PCN #: 20070518001
Texas Instruments Incorporated
Enterprise Notification

**Addition of RoHS Designation
Symbols to Semiconductor
Product Labels**

Release Date: July 21, 2007

Example: Non-RoHS Compliant Products (RoHS compliant except for Pb, no exemption)

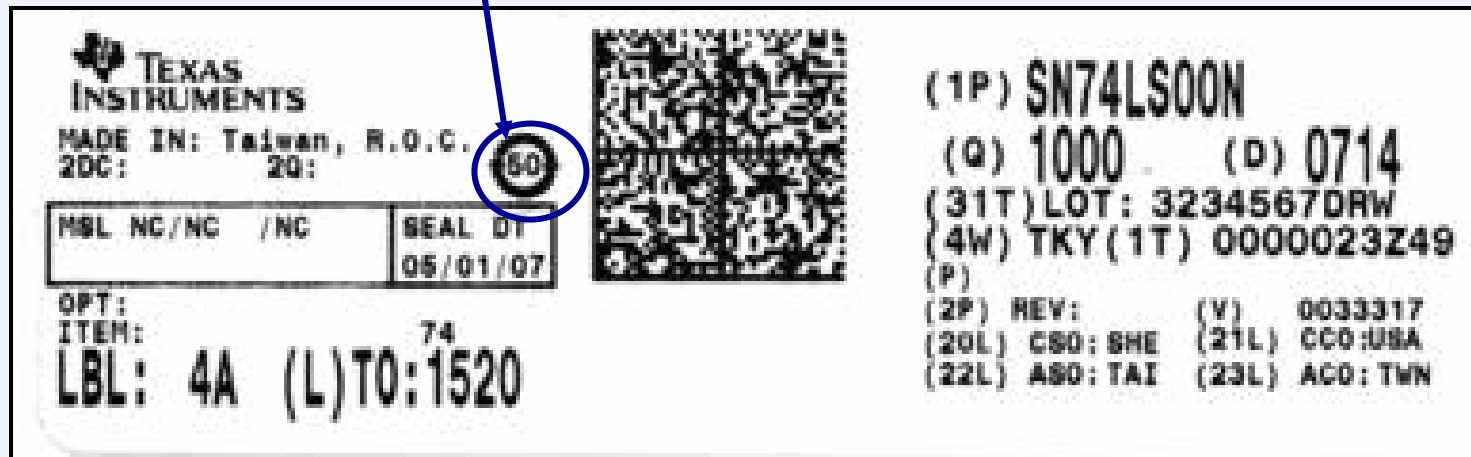
- New ECAT Symbol: per proposed J-STD-609 format

Default: Same as Non-RoHS Compliant

- Default label if banned substance not defined within TI internal traveler system
 - Device is without an EU RoHS exemption and
 - Pb may exist above the 1000ppm MCV
 - Then label will include China RoHS Chasing Arrow with 50 year EFUP
